**From:** Habib, Donald  
**Sent:** Wednesday, January 10, 2018 4:10 PM  
**To:** Vogle PEmails  
**Subject:** Vogle COLs - Technical Meeting on Shake-Space LAR January 11, 2018  
**Attachments:** Slides to Support LAR 205 Discussion.pdf

# Seismic Gap Changes SNC LAR-18-002 (WEC LAR-205)

- Technical exchange meeting to discuss seismic gaps between nuclear island and adjacent buildings
- Receive and Address Staff Feedback

# Change 1: Seismic Gaps between Nuclear Island and Seismic Category II Buildings

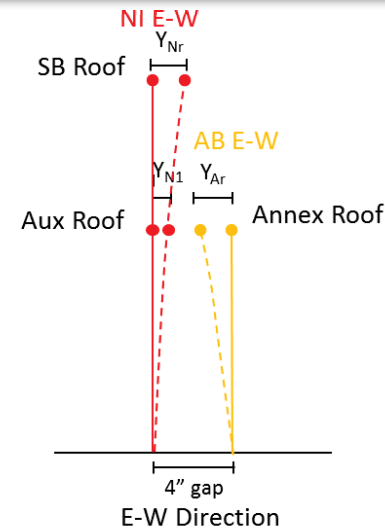
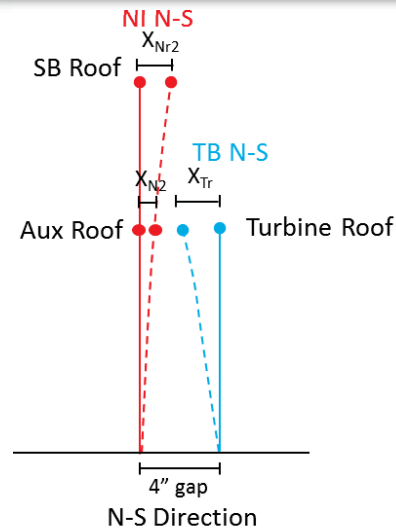
- Challenges with maintaining the minimum 4" gap during construction.
  - NI and TB gap constructed <4" at one localized area.
  - Additional localized exceedances may be identified in future concrete pours.

- Reduce the minimum construction requirement from 4" to 3".
- Update calculations to continue to demonstrate the design acceptance criteria (1" minimum gap during seismic event) is met.

# Change 2: Seismic Gaps between Nuclear Island and Non-Seismic Buildings

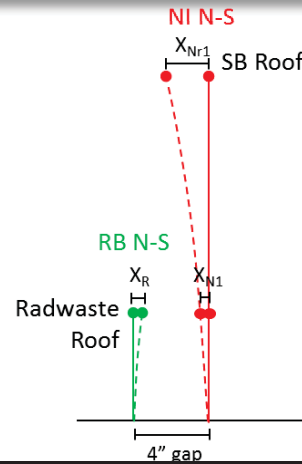
- The gap between the NI and the RB is not an input to the impact evaluation of RB on NI, therefore it does not affect the acceptance criteria of RB.
  - It is not meaningful to perform the ITAAC inspection on the RB gap when it does not contribute to the design/analysis.

- Delete the requirement of gap between the RB and NI in Tier 1 Table 3.3-6, item 13.
- Modify UFSAR Subsection 3.7.2.8.2 from a minimum 4" clearance to a nominal 4" clearance.
- Update calculations to continue to demonstrate the design acceptance criteria (no impairment on NI integrity) is met.
